***Information Disclosure Statement:***

***Claim Rejections - 35 U.S. C.112:***

***Claim Rejections - 35 U.S. C.102:***

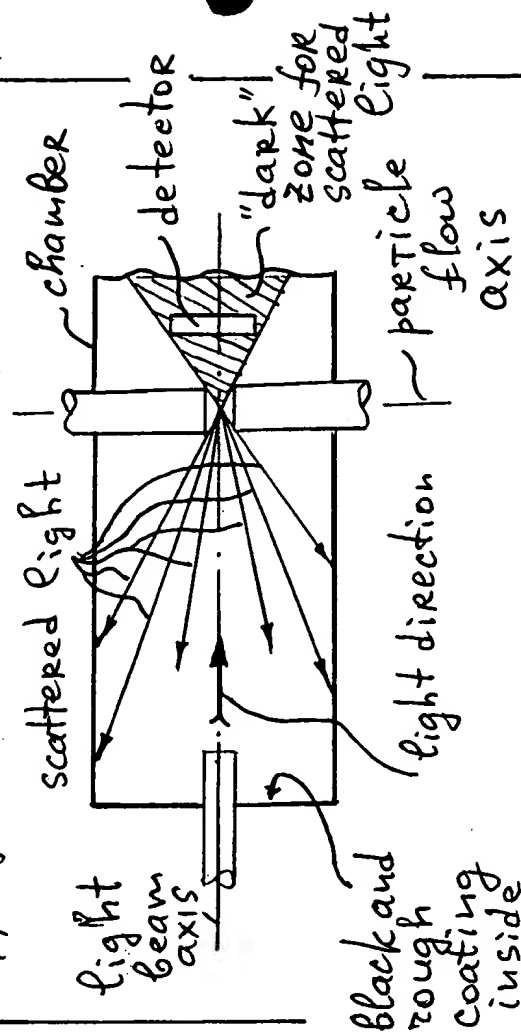
An improved methods and device (Claims 1-15) eliminate any optic means for focusing, because the point of intersection of the light beam with the particle flow is particularly in the area of the detection means, that provides the elimination of any windows, gates, lenses, etc. and also eliminates a light noise, producing by scattered light.

This is possible, because the improved method (Claim 1) and device (Claims 6-15) provide the elimination of the scattered and non-focused light (please, see figure below). Please, see also lines 4-9 of the top on page 5 of Rewritten Specification.
